Application No.	21235	Type	Site Plan		
Project Name	Six Range Condominiums				
Summary	Proposal to develop an undeveloped parcel with 8 buildings, including 3 apartment buildings, 1 commercial building, and 4 3-unit rowhouse buildings, totaling 192 residential units. The Applicant requested a Departure from a Block Frontage transparency standard for one of the mixed-use buildings (Building A), for the façade facing West Babcock.				
Zoning	R-O, Residential Office	Growth Policy	Urban Neighborhood	Parcel Size	8.64 acres
Overlay District(s)	None				
Street Address	4720 West Babcock Street, Bozeman, MT 59718				
Legal Description	Lot A1 of Minor Subdivision 338, S10, T02 S, R05 E, City of Bozeman, Gallatin County, MT				
Owner	Paine Group, Matt Paine, PO Box 418, Bozeman, MT 59715				
Applicant	MFGR Office, 125 N. Wallace, Bozeman, MT 59715				
Representative	Justin Harmon, 125 N. Wallace, Bozeman, MT 59715

FINDINGS OF FACT AND APPEAL PROVISIONS CERTIFICATE

Figures 4: Building Elevations

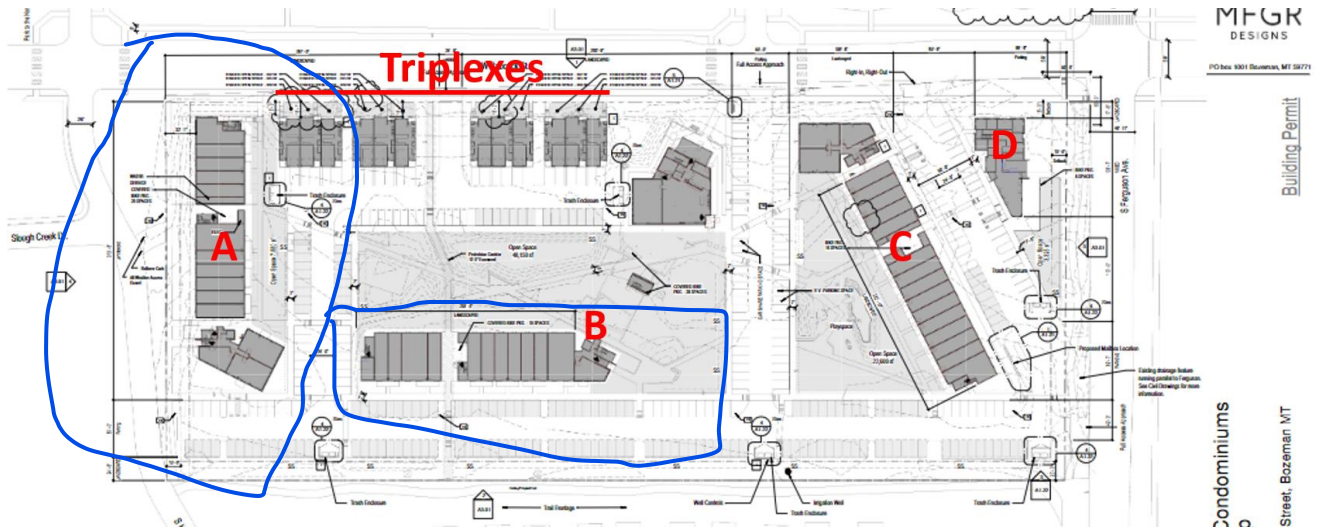
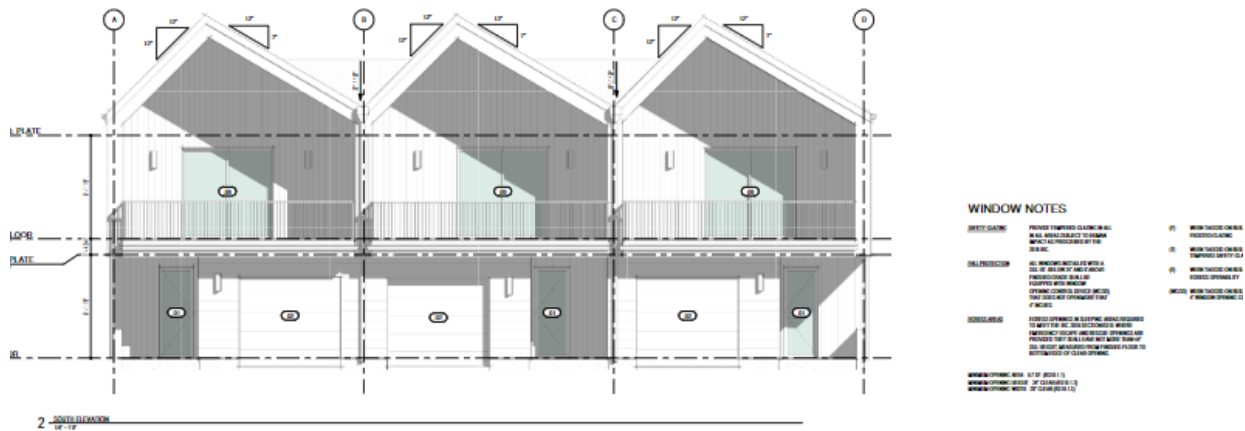
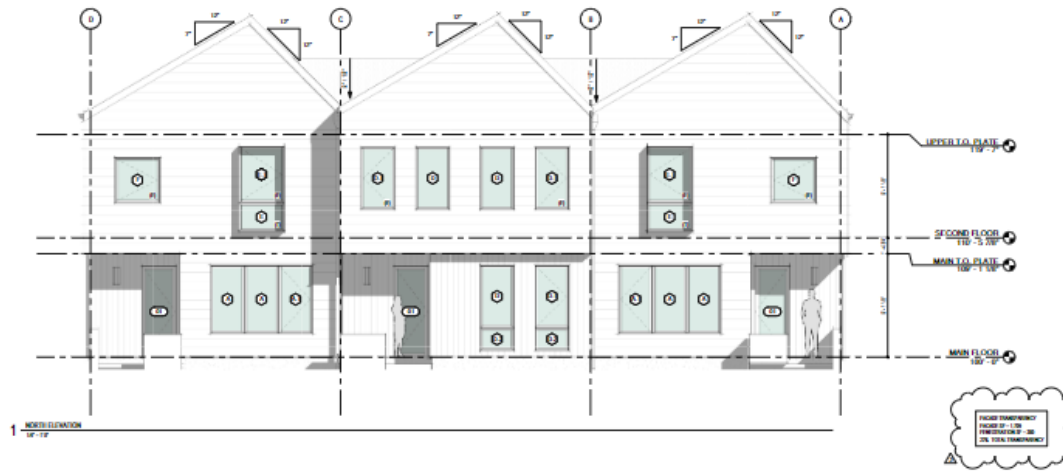
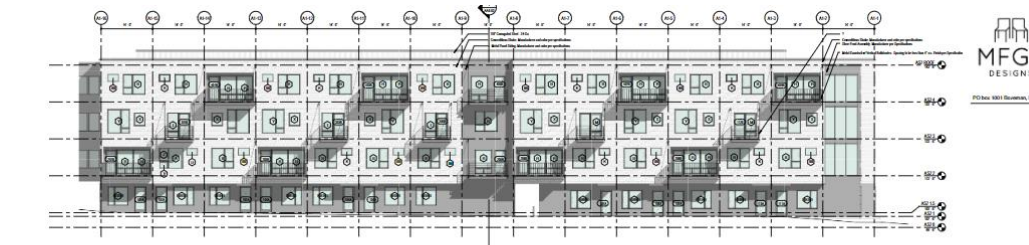
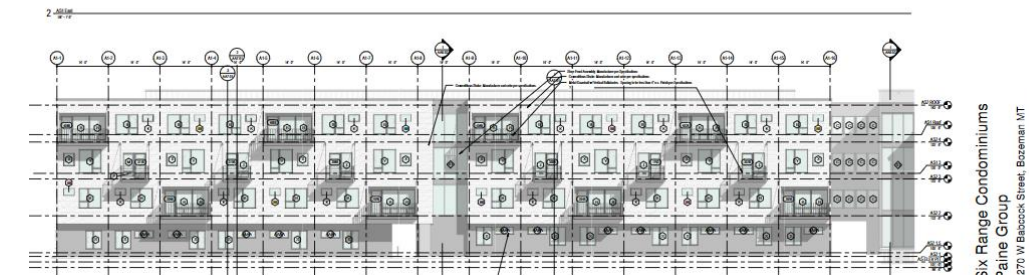
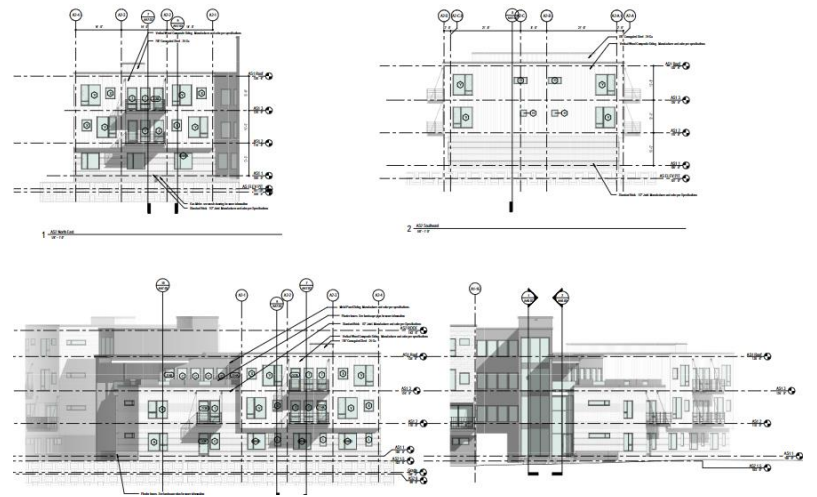
Applicable zone specific or overlay standards 38.330-40			NA
Comments: There are no zone specific or overlay standards for this site and zone.			
General land use standards and requirements 38.350			Yes
Comments: The proposal meets the standards and requirements.			
Applicable supplemental use criteria 38.360			Yes
Supplemental uses/type	38.360.100 - Condominiums 38.360.250 – Townhouse and rowhouse dwellings		Yes
Comments: The application is required to meet the additional supplemental criteria for townhouse/rowhouse dwellings. This includes providing private fenced open space areas in front of each rowhouse, which is proposed. Each rowhouse unit has adequately sized garages for parking and backing maneuverability. The design of the rowhouses provides articulation at a cadence consistent with the width of the buildings. This articulation is provided by reversing one of the buildings entrances and varying the design of the windows on the center unit.

Block frontage classification	W. Babcock – Mixed/landscape S. Ferguson Ave – Mixed/landscape Special Residential along sidewalks and internal pathways.	Yes, with the Director's approval of the departure request
Departure criteria	Yes, North Façade of Building A, transparency	Yes, with departure approval
<p>Comments: The proposal has multiple block frontages it is required to meet. To the north and east, West Babcock and South Ferguson Ave respectively have mixed block frontage designations, to which the applicant has chosen to apply the landscape block frontage standards. Internally on the site, the buildings orient towards internal sidewalks that require special residential block frontage where residential is on the ground floor facing the sidewalk. The proposal meets the block frontage standards with one departure request ,which is discussed below.</p> <p><u>Departure Request:</u> Building A's northern façade is facing West Babcock St, which requires the mixed/landscape block frontage. The applicant has requested a departure citing that "new windows would either be placed in closets or the exit stair which already has a fully glazed wall. More windows would also reduce the performance of this façade." Departures are allowed per 38.510.030.C.3, which lists criteria that the proposed alternative design treatment of façade area between ground level windows provides visual interest to the pedestrian and mitigates impacts of any blank wall areas. Staff supports the departure based on the trellis treatment with clematis proposed as the growing vine. The building is setback from the street 16' and has landscaping provided between the building and the street softening the impact that the lack of transparency will have for pedestrians.</p>
